Metropolitan Planning Commission

Staff Reports

September 27, 2012

Proposed Plan

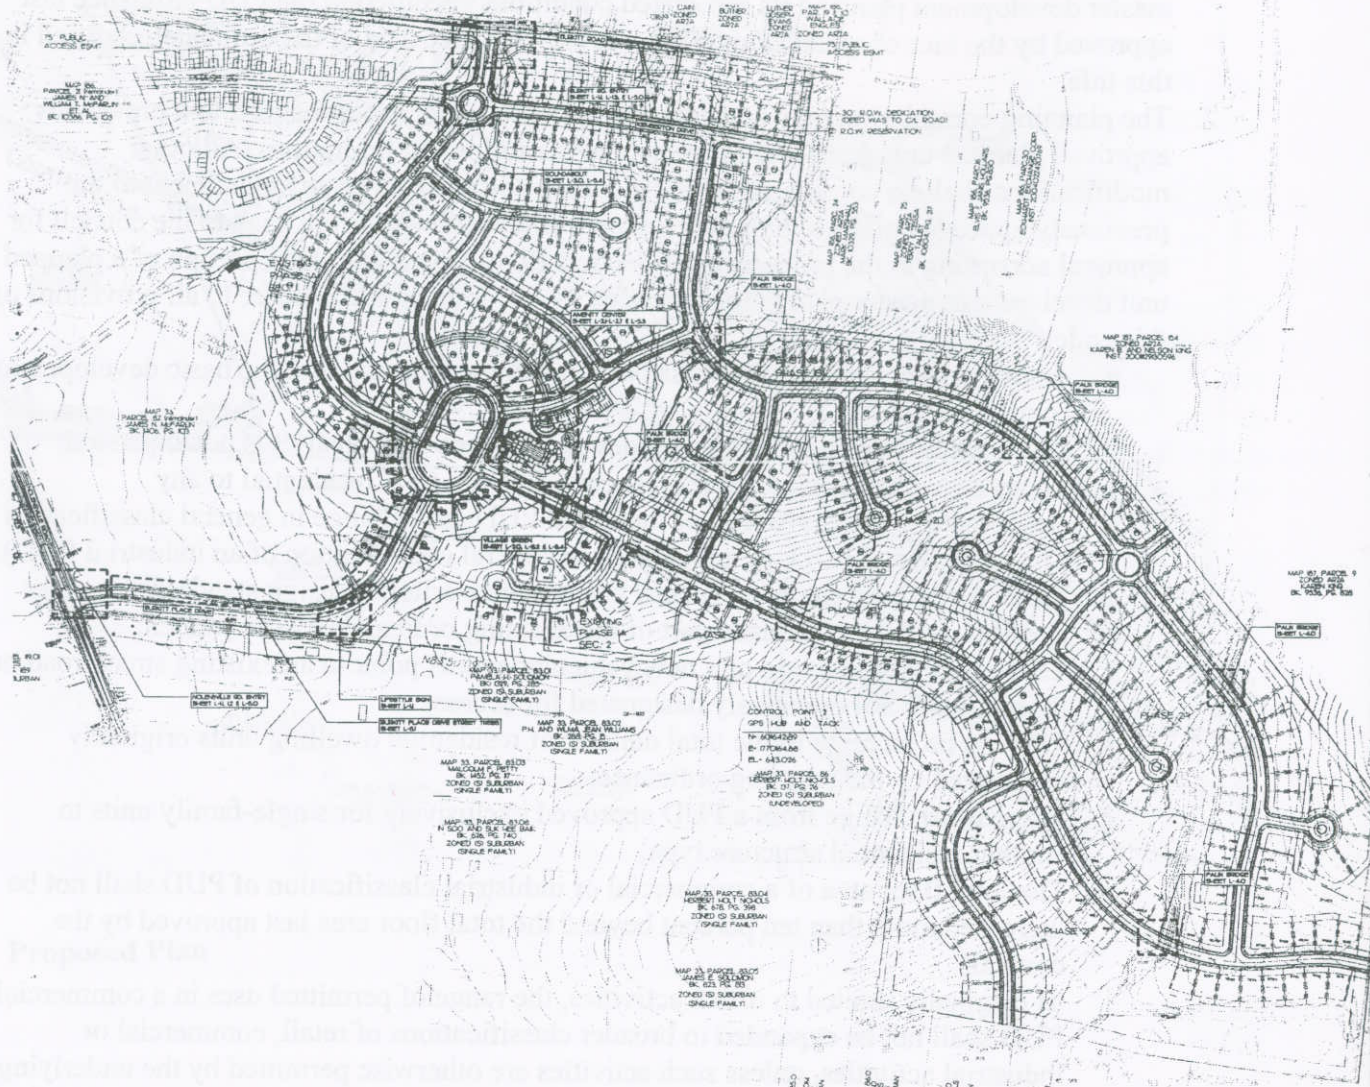
1. Provide 2 additional sets for approval.
2. Provide revised storm pipe calculations showing no surcharge.

2. Add MPW standard construction notes to the cover sheet:
 - a. All work within the Public right-of-way requires an Excavation Permit from the Department of Public Works.

- d. Street signs to have six inch white letters on a nine inch green aluminum blade.
 - e. All signs to have 3M reflective coating.
 - f. Remove note on Cover Sheet about PUD.

3. Include landscape plan with all planting in the ROW. Add the following statement to the plan "If a tree dies with three years of being planted the developer is responsible for its removal."

4. Submit striping and signage plan.
5. Add note to construct curb ramps at intersections to facilitate pedestrian crossings and to align ramps at intersections.

6. Add note that all driveways are to be MPW standard ST-324.

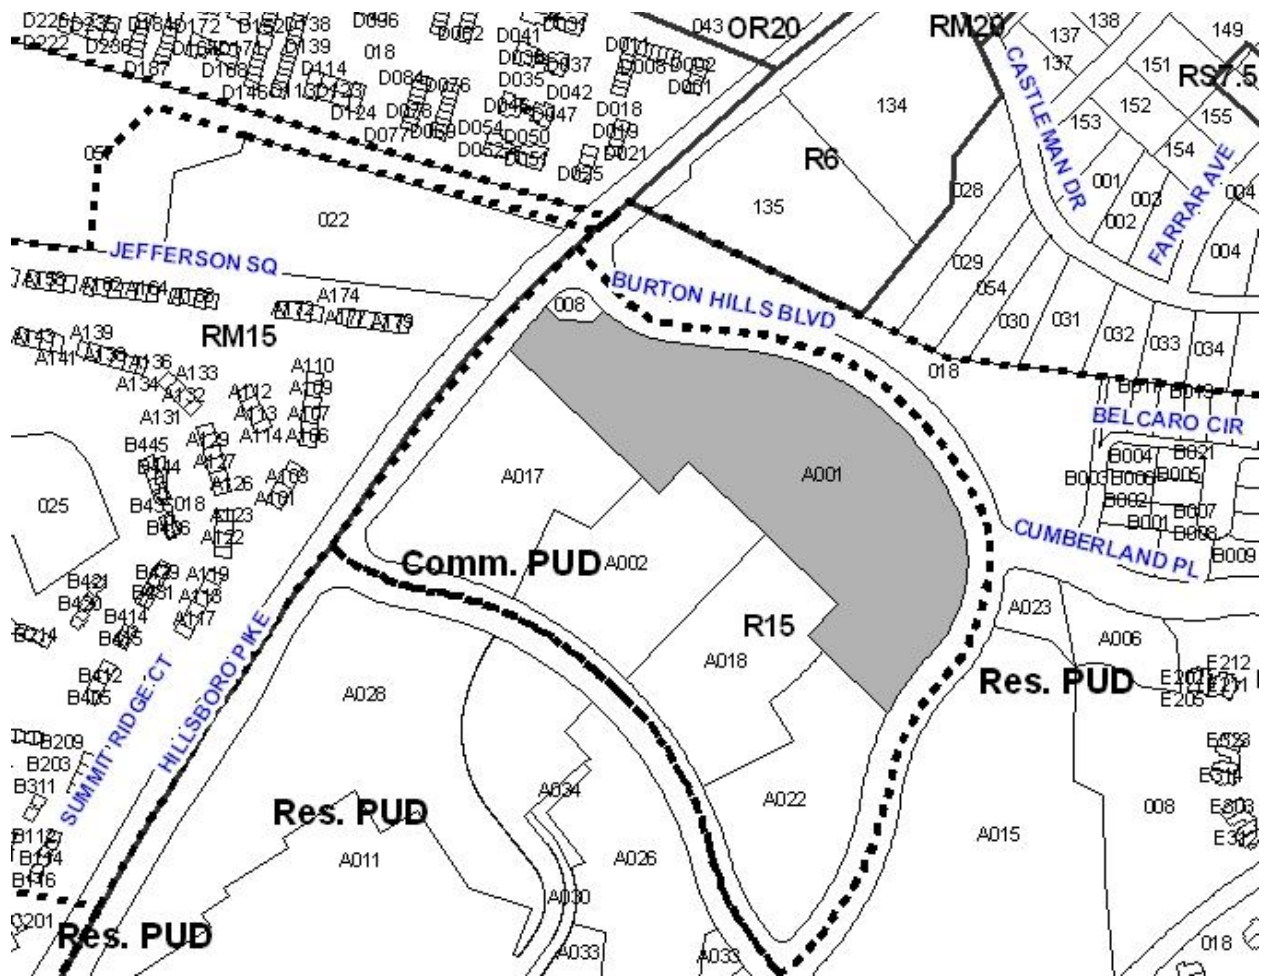
We must hold our review of the subject plat until the necessary construction plans are submitted and approved (detailed in our forthcoming letter). Please have applicant coordinate with Mr. Alan Hand on this topic.

Install final top coat of asphalt to the intersection of Lake Villa and Murfreesboro Rd.
